- 20.11.19 Planning Application NMA Review

PROJECT:
John Dalton House
Manchester

TITLE:
Proposed Sections
Sections AA & BB

PROJECT DRAWING NO: 05441 B2_05_2200_NMA REV: -

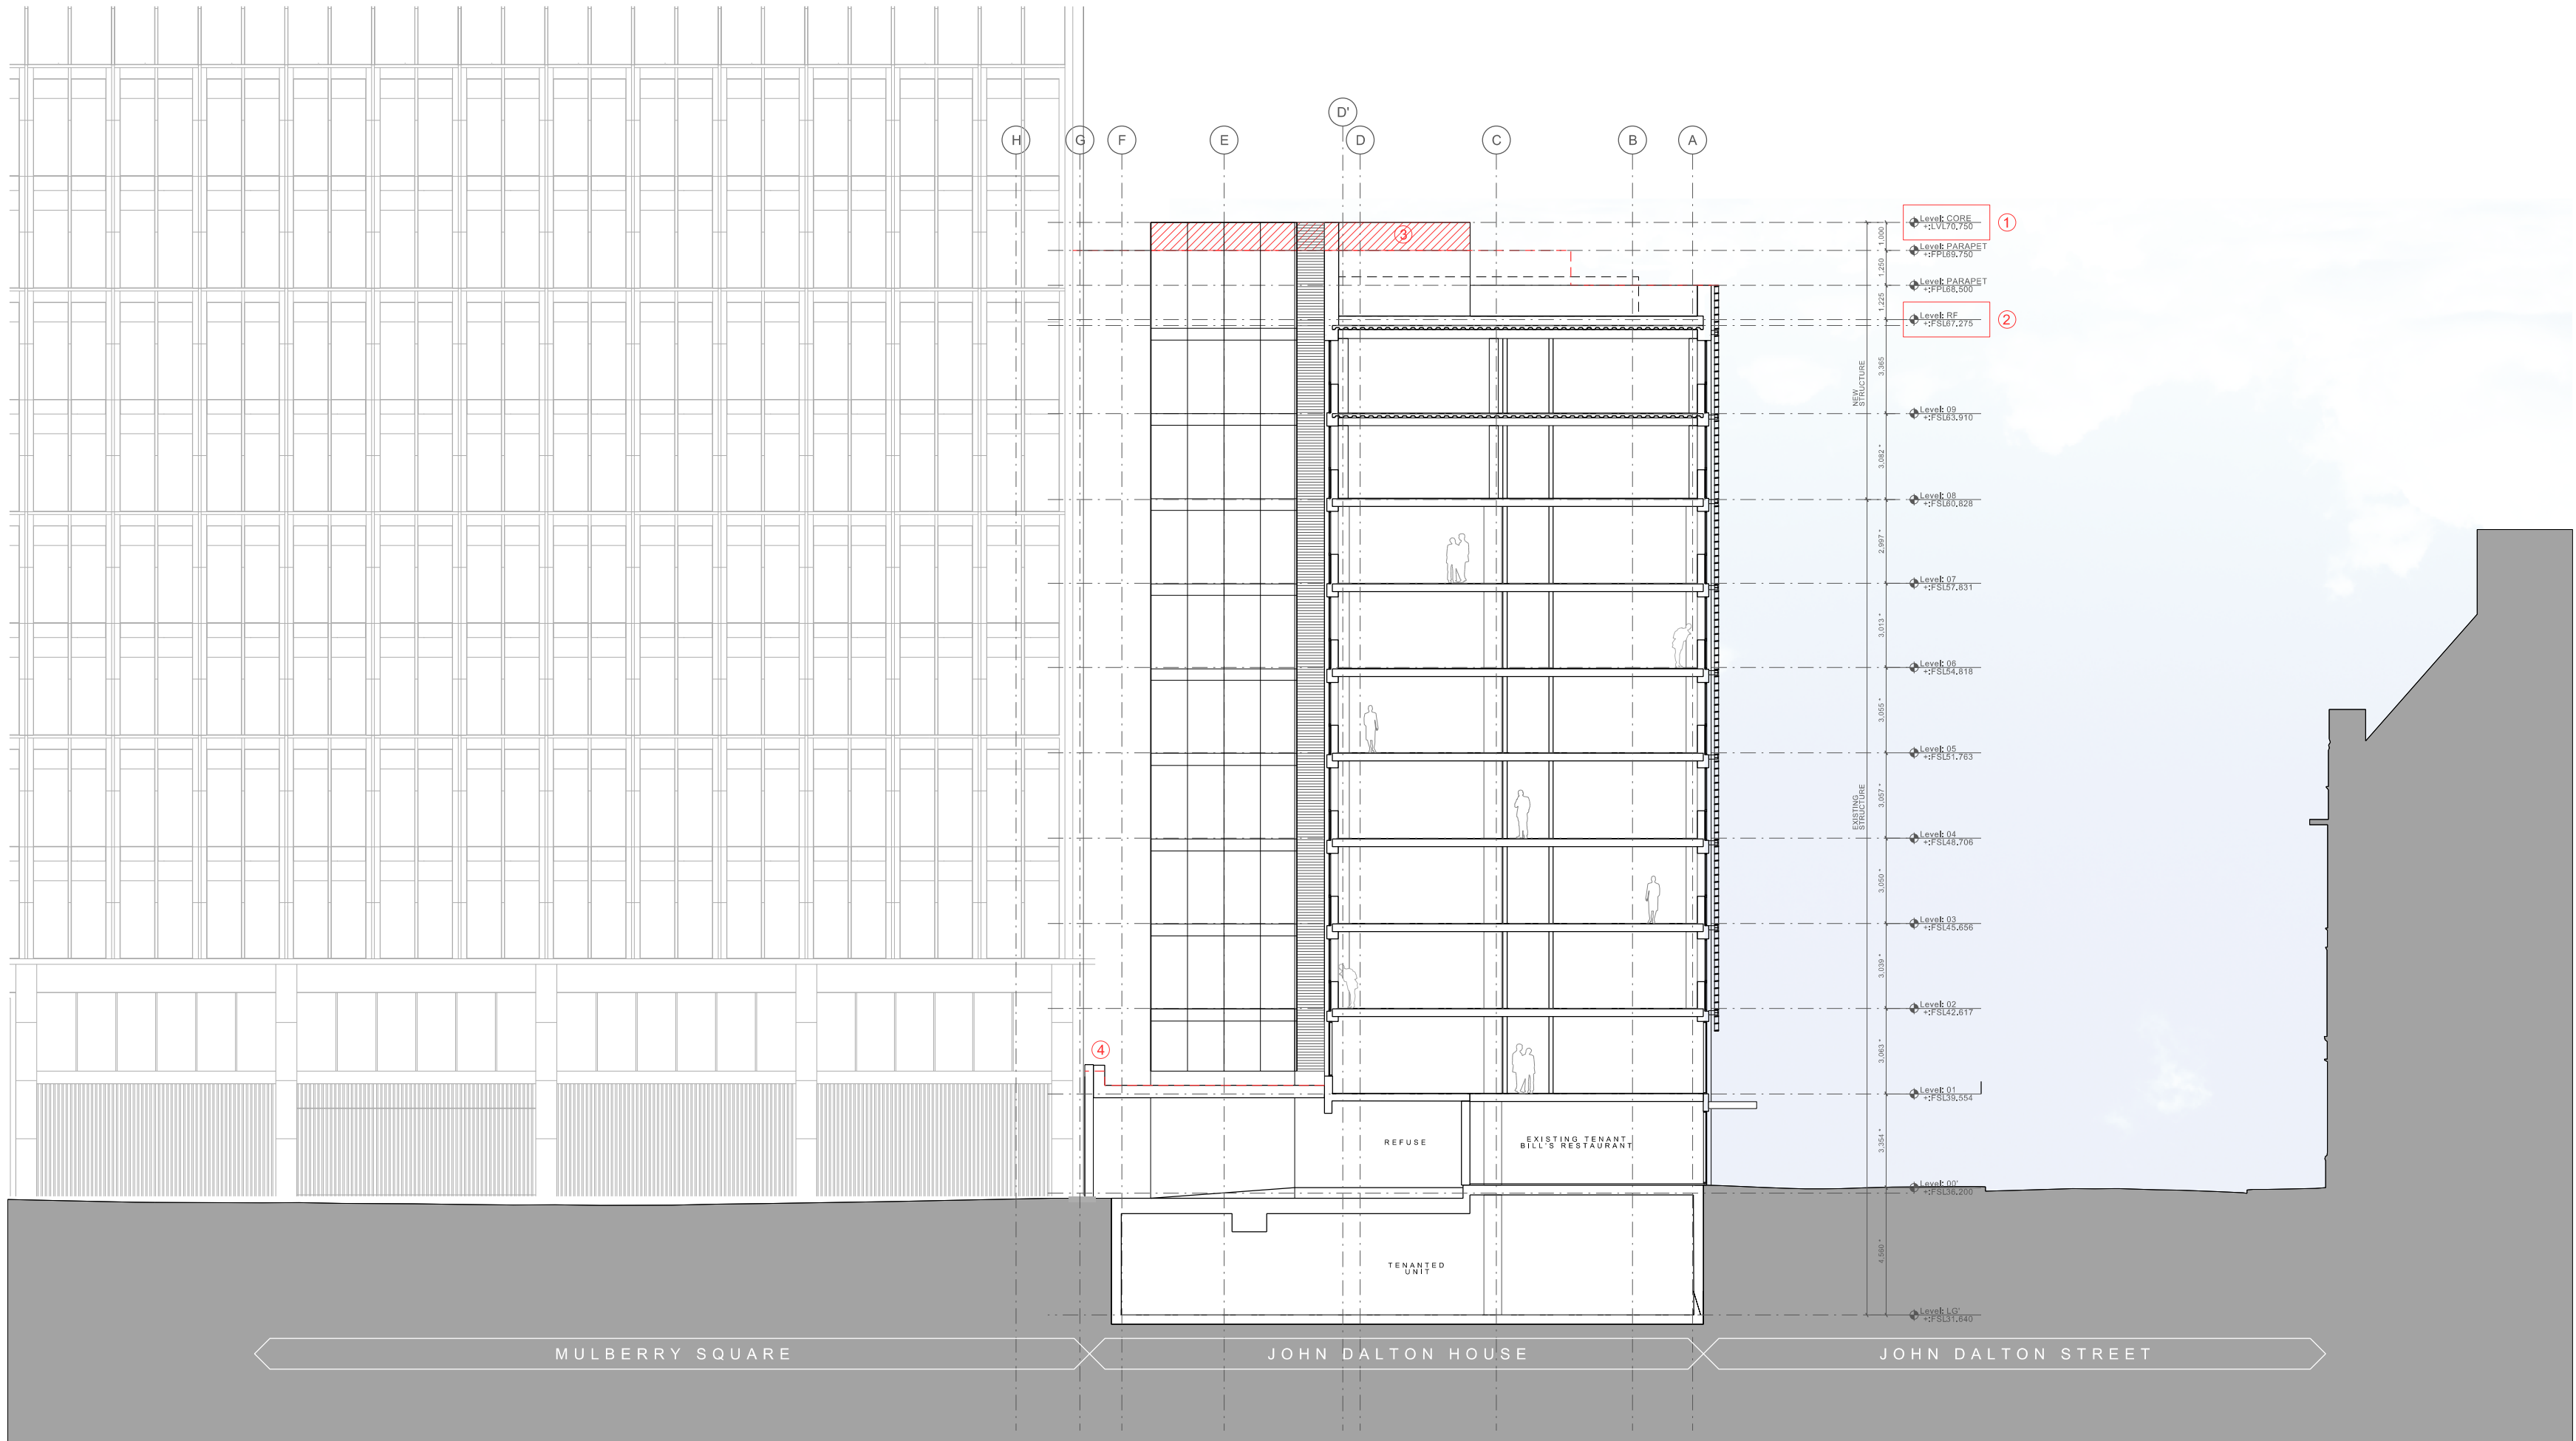
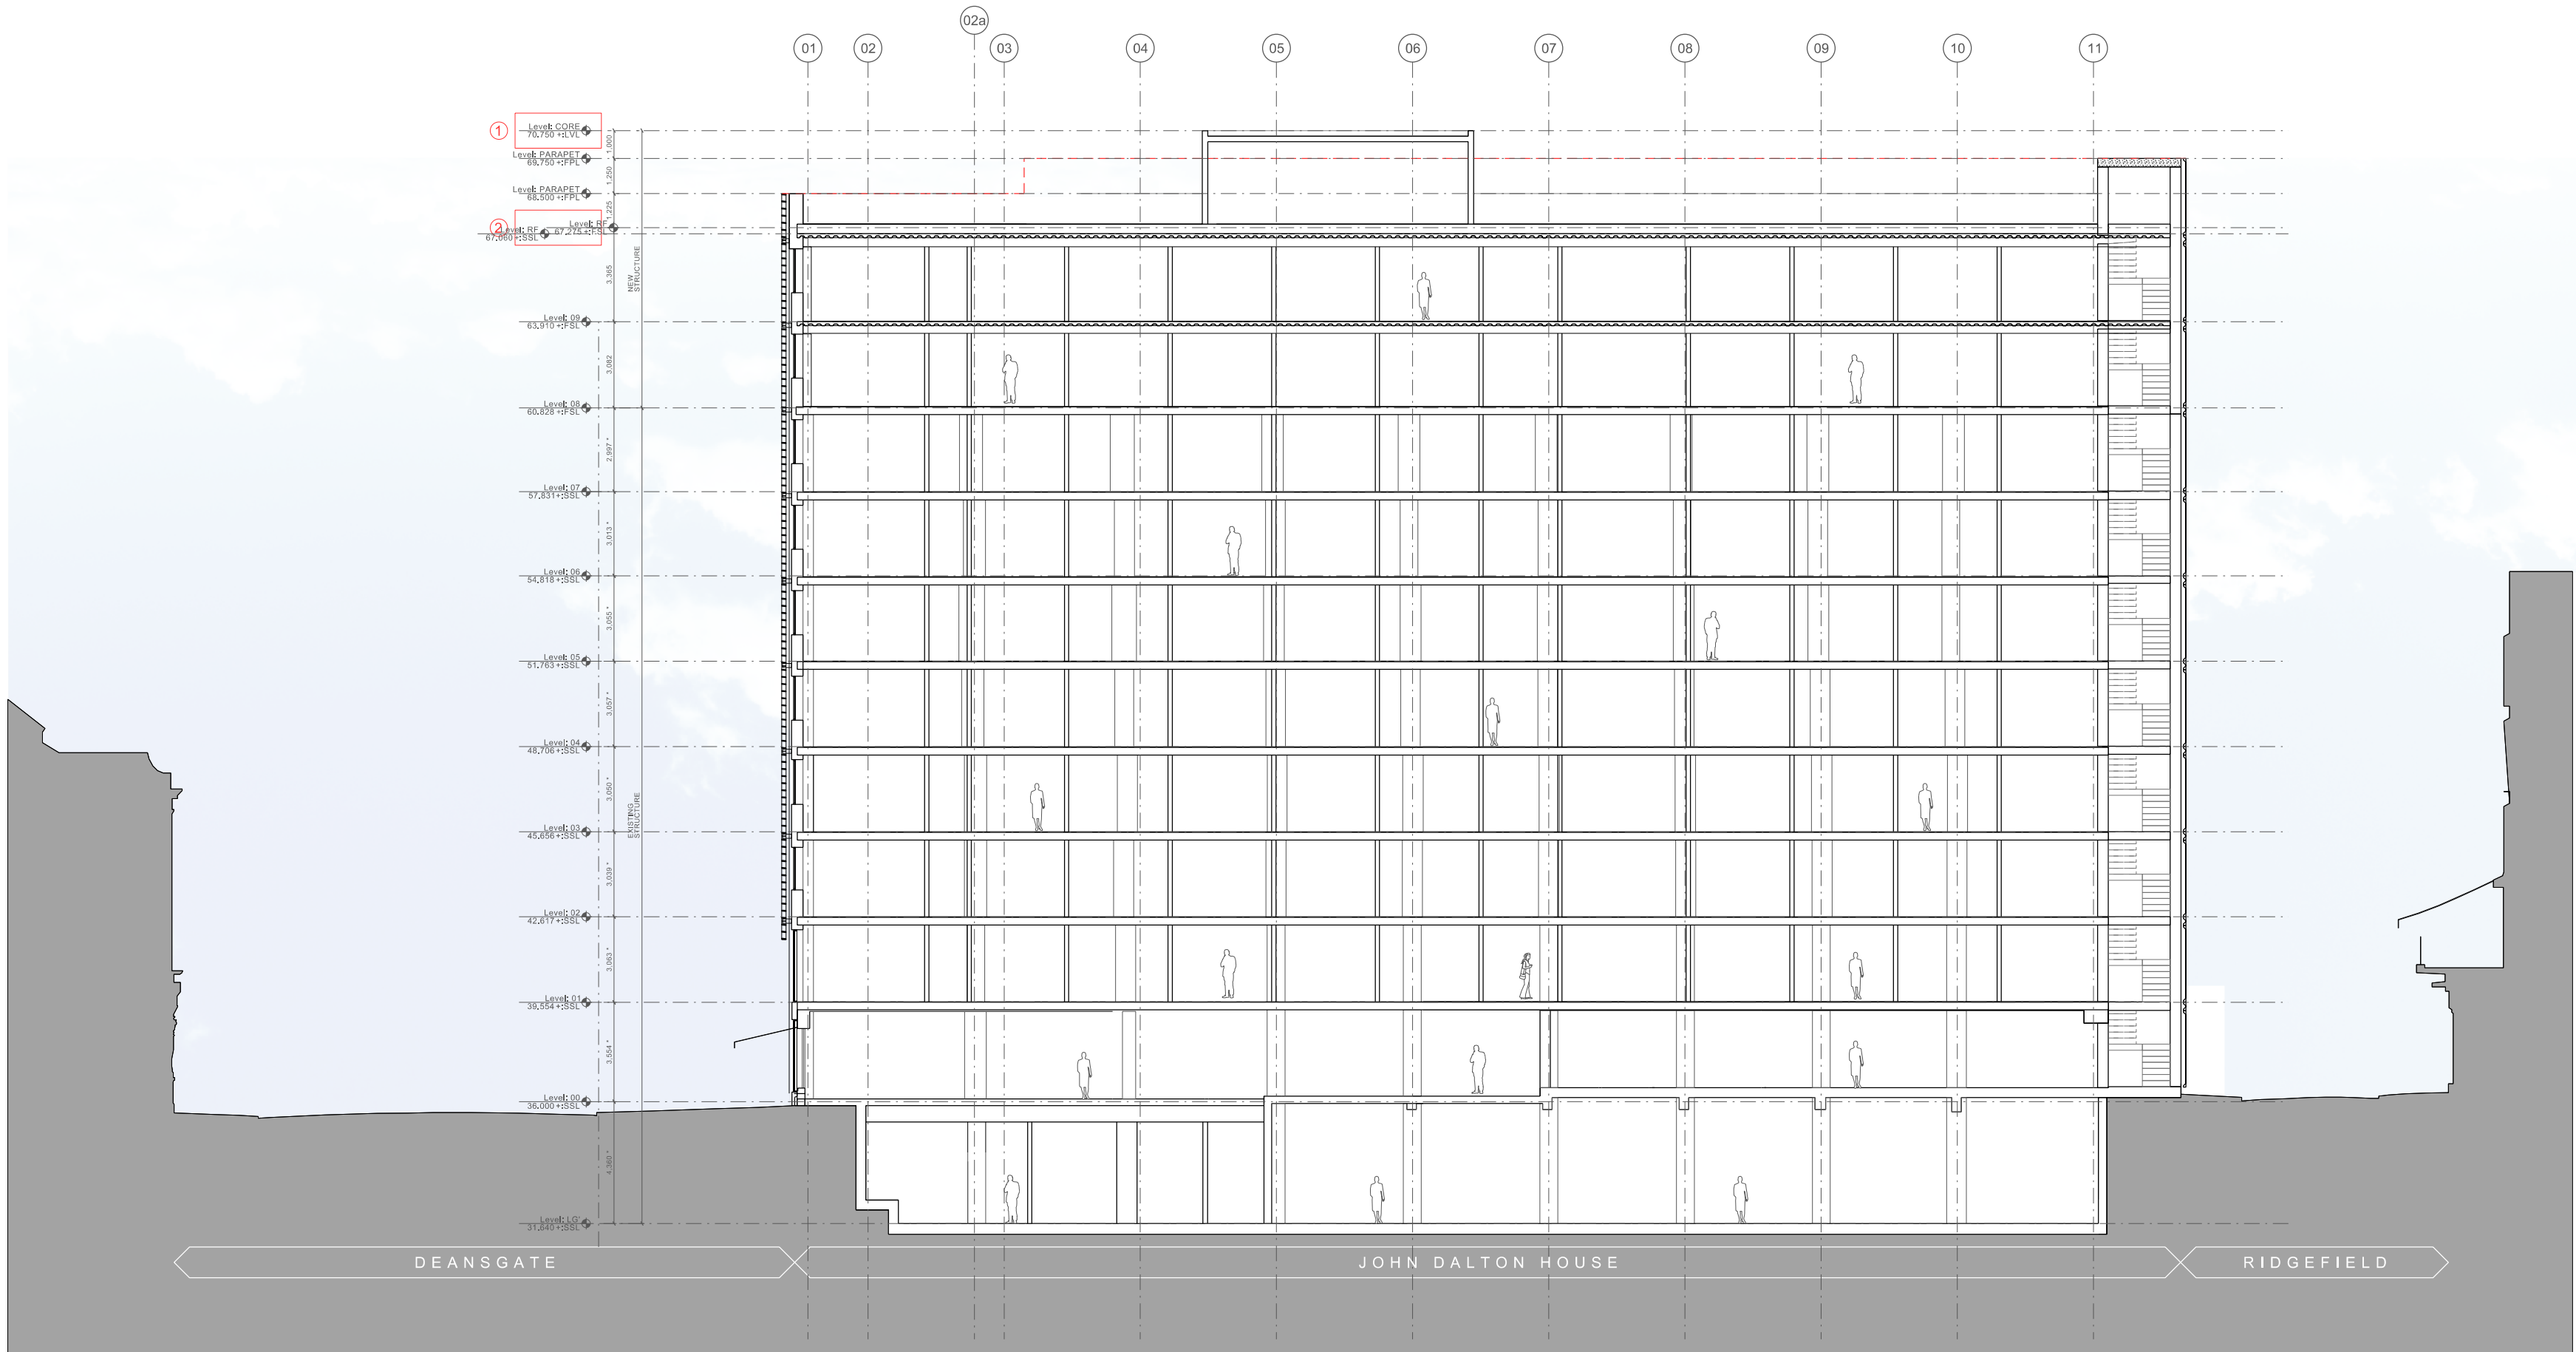
REVISIONS TO APPROVED SCHEME

1. Level: FLUE amended to 'CORE' - 150mm increase in height

2. Level: RF - 175mm decrease

3. Plantroom adjustment

4. Parapet detail to low roof extended to match current structural situation
